HARTING Product Change Notification

PCN/22/009/C+N

Title: D-Sub W - Change of contact plating on termination side - External

Example 9-Pin Version 09675096758:

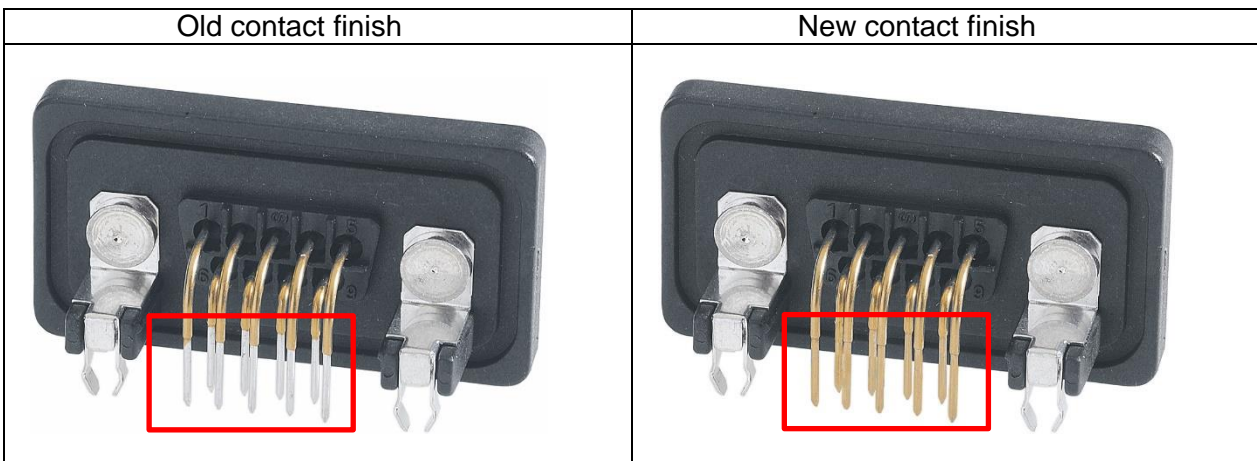
To harmonize our D-Sub Portfolio with turned contacts we will change contact plating of D-Sub **Waterproofed** on termination side to our common standard.

Pre-tinning of the signal contacts in the termination area is omitted. The contact surface remains gold-plated throughout.

Please find below the optical comparison of the old and new version.
